**GRAVEL ROAD REVISION
PROPOSED CROSSING
3 MILES S. OF LONDON**

NEW BRIDGE AT HIGHWAY 401 LINE "C"
UNDERPASSING THE PROPOSED GRAVEL ROAD
REVISION, ABOUT FIVE MILES SOUTH OF
LONDON, TOWNSHIP OF WESTMINSTER.

SETTLEMENT STUDY
BOSTWICK ROAD OVERPASS
W.P. 98-57, HIGHWAY 401
DISTRICT NO. 2, LONDON

Memo to Mr. A. M. Toye, *Date* Aug. 3, 1962.
Bridge Engineer. *Subject* FOUNDATION INVESTIGATION REPORT
From Materials & Research Division. *by:* Wm. A. Trow & Associates Ltd.

BORE HOLE LOCATION PLAN
SCALE 1" = 20'

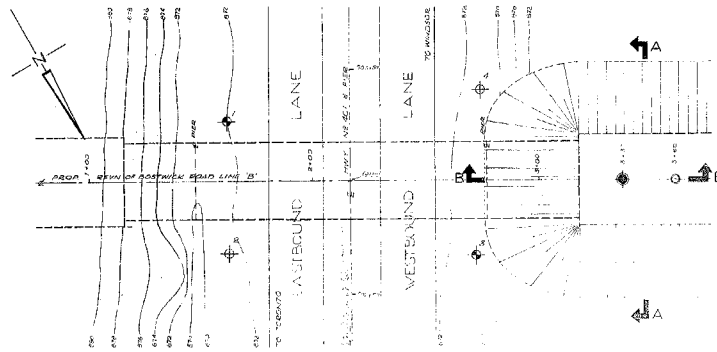
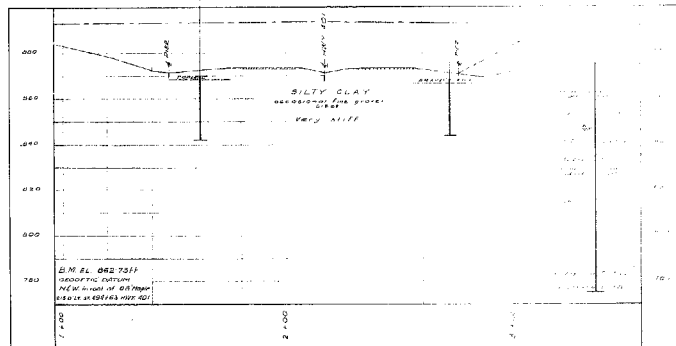
In this recently completed investigation, one borehole was put down a short distance beyond the proposed west abutment in the position shown on drawing 1. This location, on the west side of the highway was chosen because the embankment fill will be highest under this approach.

The result of this boring is shown in the log, presented as drawing 2 of this report. The relevant data of this work and of the preceding investigation is summarized in stratigraphical form on drawing 1.

These assumptions are summarized on drawing 1.

It is considered that the above noted shear strength of 1700 pcf is not consistent with this apparent desiccated condition. This low strength measurement could result from the unconfined method of testing, in which there was no confining pressure to prevent premature failure of the soil by "bursting". Accordingly, one triaxial compression test was performed on a sample from a depth of 8 feet in the recent borehole. The result of this test, presented on drawing 12, shows a strength in excess of 8000 psf, which is consistent with the apparent desiccated nature of the soil.

soil encountered during this recent work, is not consistent with the original recommendation of the relatively low bearing value of 2 tsf.

Substituting these values, a net safe bearing capacity of 6000-psf is computed. This permissible stress is believed to be quite conservative at the west abutment location, but is probably more truly applicable near the borehole 1 location of the original investigation.
